Review Comments #2

Project:Brighton Recovery Campus-Building CFrom:Jason WorthenProject No:20160686Date:April 12,2017

BUILDING C RESPONSES

EP601 (see attached sheet)

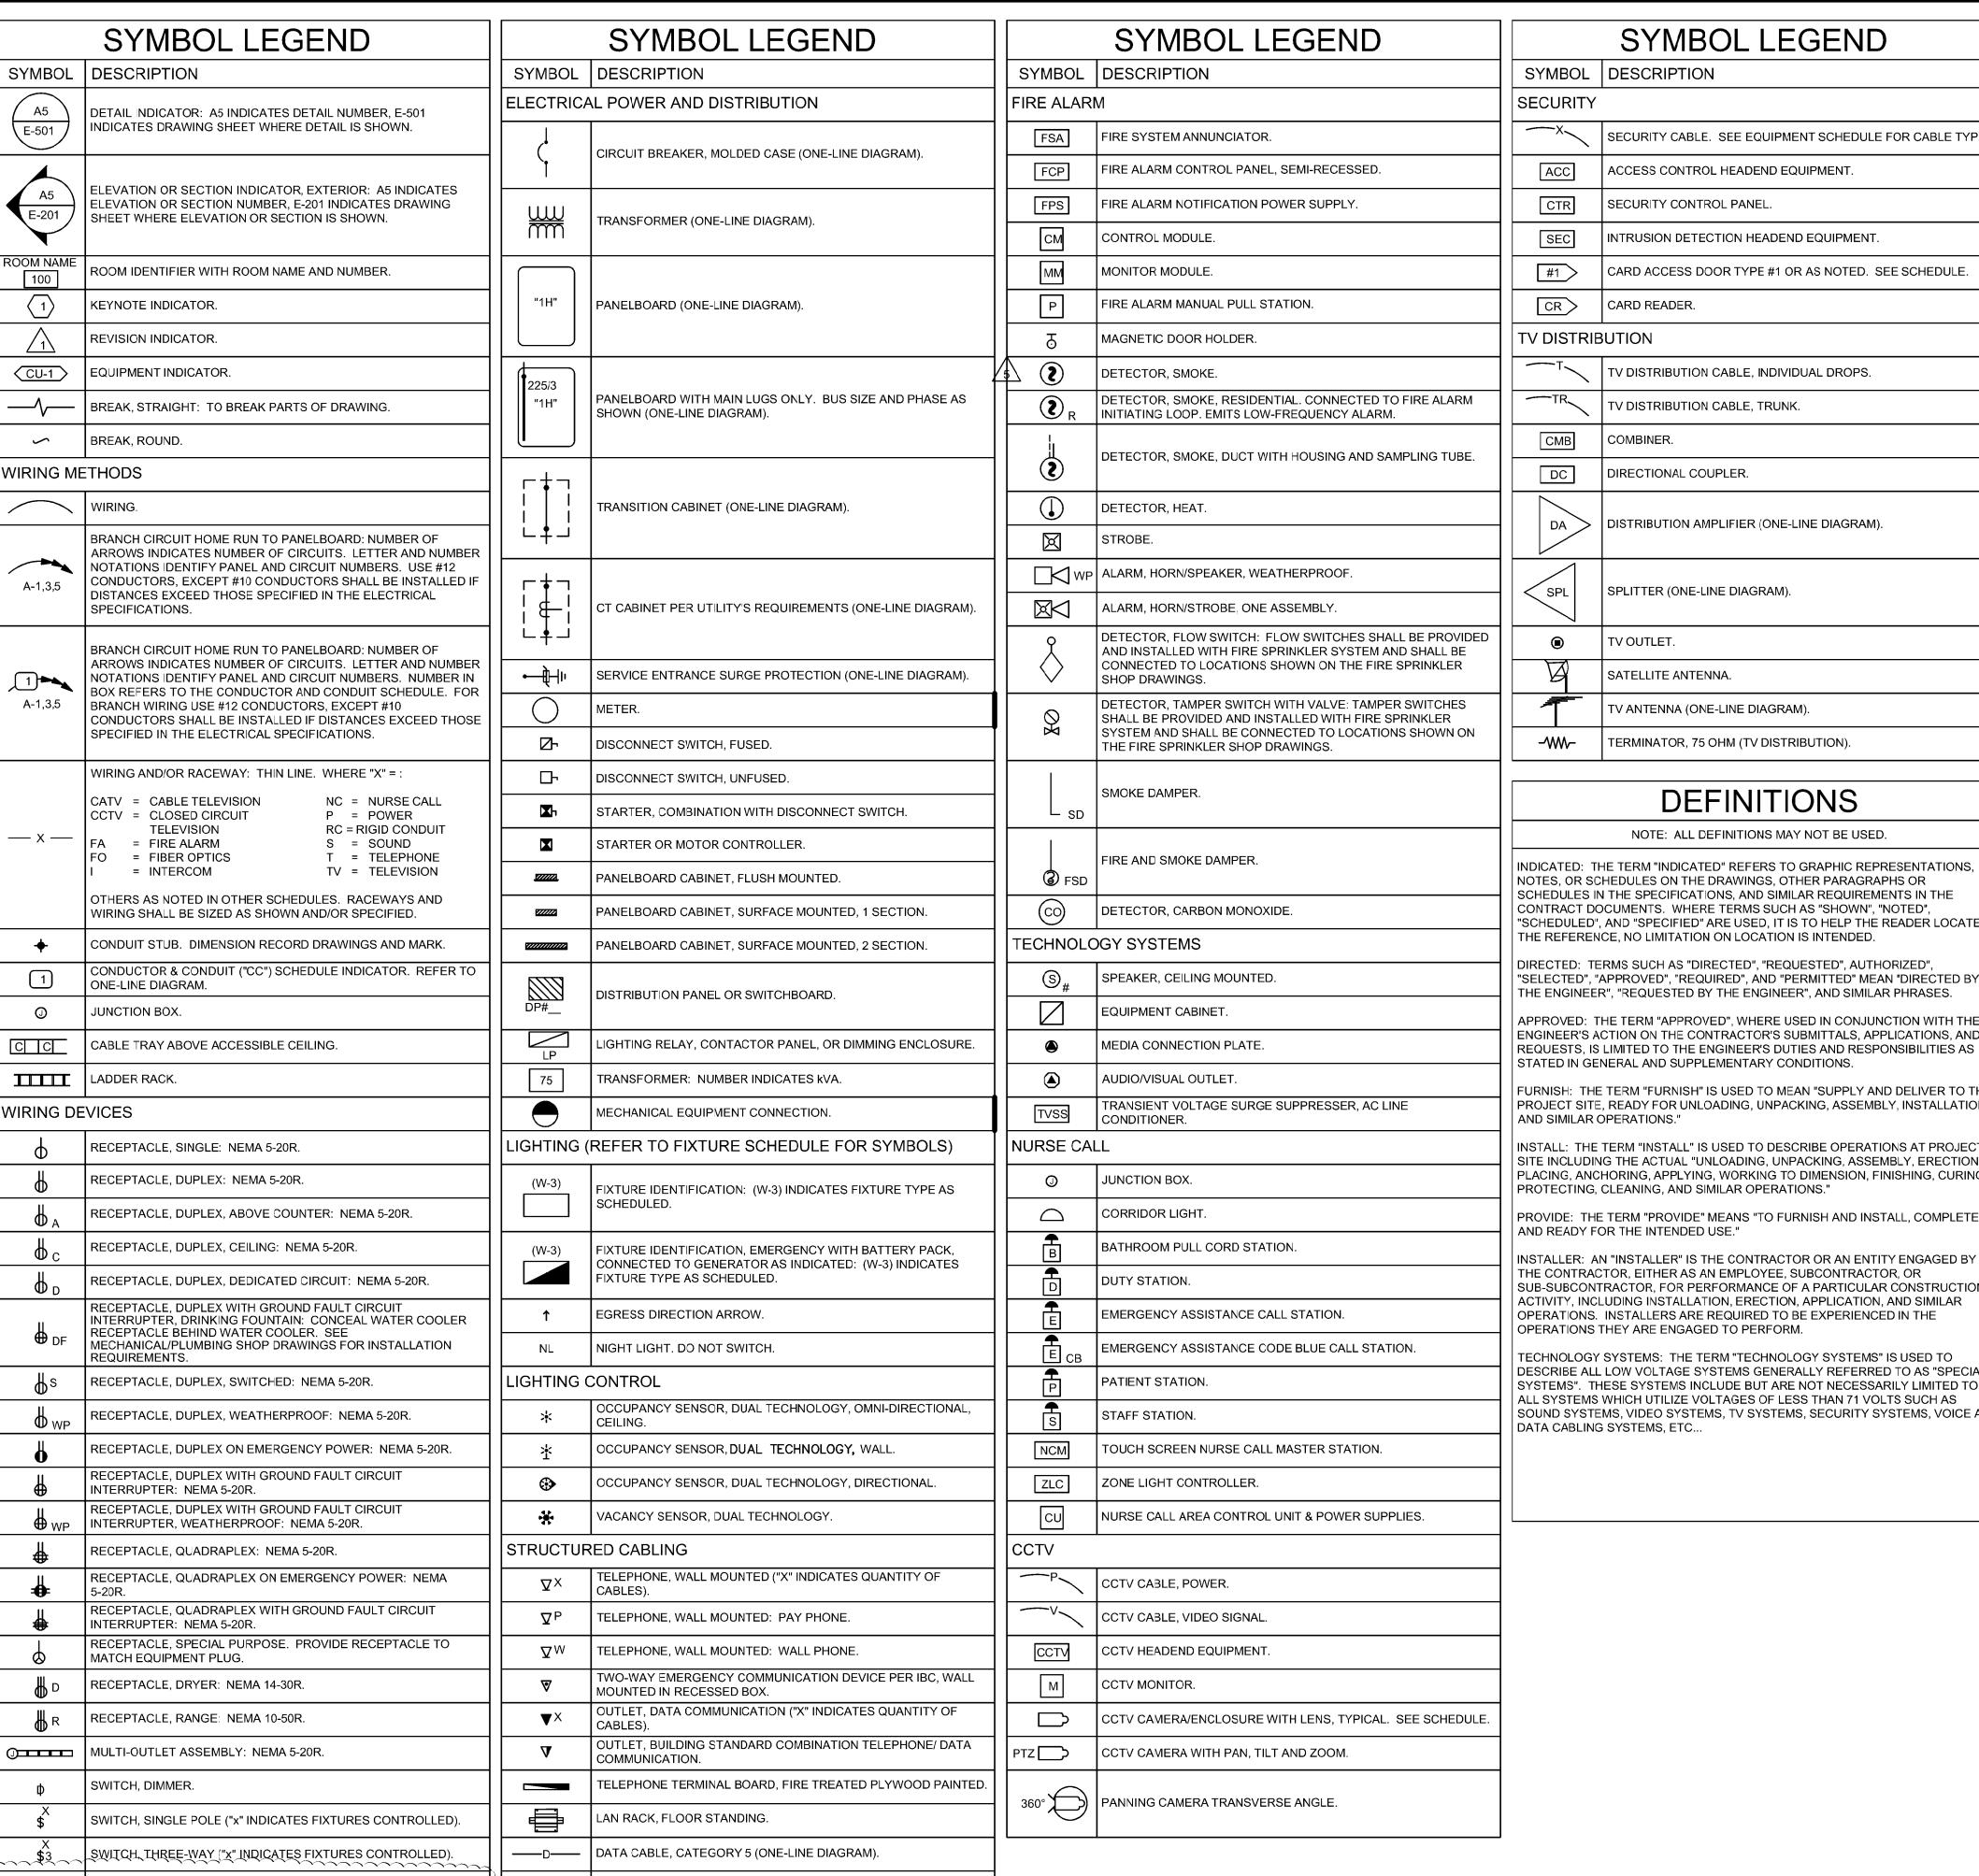
E5. Sheet EP601: Please address the following:

C. Per NEC 250.32 a separate grounding electrode is required to be provided for each of the buildings supplied by the feeders from building A. Please clarify how this grounding electrode is to be provided. Where no grounding electrode is available please provide grounding electrode per NEC 250.50.

I. Please specify the size of the grounding electrode conductor to be provided to the grounding electrode per NEC 25.032(E) and NEC 250.66.

Response: Updated one-line diagram to show grounding electrodes and grounding electrode conductors for each building.

- 1. Changed one-line diagram to shown the grounding electrode conductors for Building A as new.
- 2. Added grounding electrodes and grounding electrode conductors for the panels in buildings B, C, D, E and F.
